Urgent Field Safety Notice

SynchroMed® II Implantable Drug Infusion Pump

Design Change of Model Numbers 8637-20 and 8637-40

Medtronic reference: FA794

Pump Survivability Specific to Non-Recoverable Motor Stall

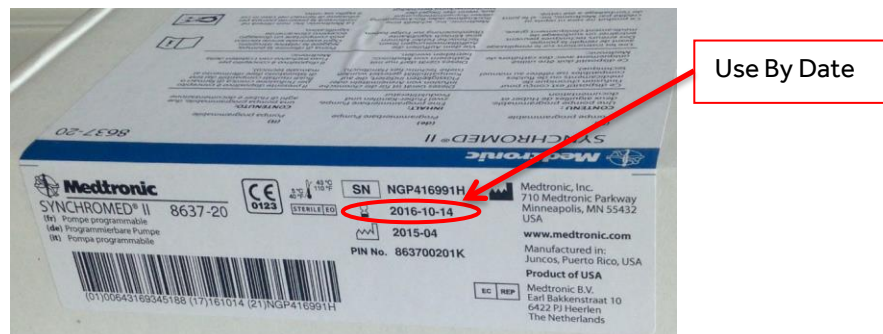
The purpose of this letter is to advise you that Medtronic has received approval to implement a design change to the SynchroMed® II implantable drug infusion pump that reduces the likelihood for non-recoverable motor stall, which can cause loss of therapy. For pumps manufactured prior to this design change, analysis of our post-market data¹ estimates the pump survivability specific to non-recoverable motor stall at six years post-implant to be 97.3%² for pumps exposed to on-label drugs and 91.1%² for pumps exposed to off-label drugs. This is detailed in the table below:

The most common contributing factor to motor stall is shaft wear and this is observed in 59% of SynchroMed II pumps returned and analyzed for motor stall. Engineering testing estimates that this new design change addresses over 99% of shaft wear and will decrease the occurrence of motor stall.
